PRSG20251114

<b>Store #1032</b>
--------------------

PM:	Address: 3500 Meridian
Drawn By: SO	City State: Puyallup, WA 98373
Date: 04.10.2025	Drawing Number: 213922-ELE1
	Page: 2

Remote Wired with  
Controlled Background Panel

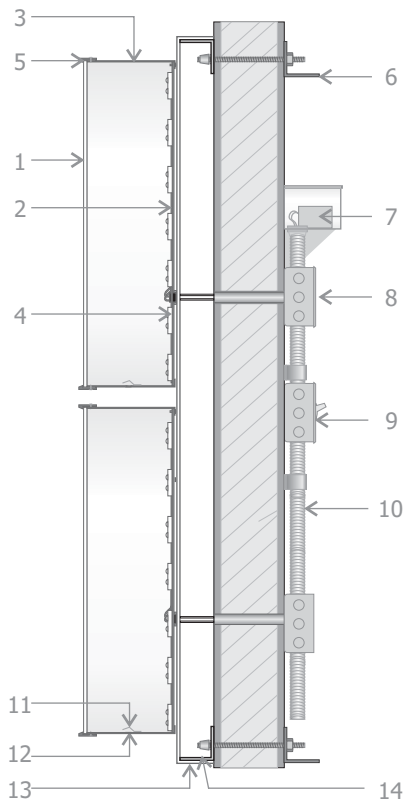
Please include the weight  
of the sign on the plan set.

Plans sets are required to have the structural information included.  
Please specify the fastener type, fastener size, fastener spacing (or minimum number required), and the existing structural member(s) the fasteners will attach to (wood studs, CMU, etc.).
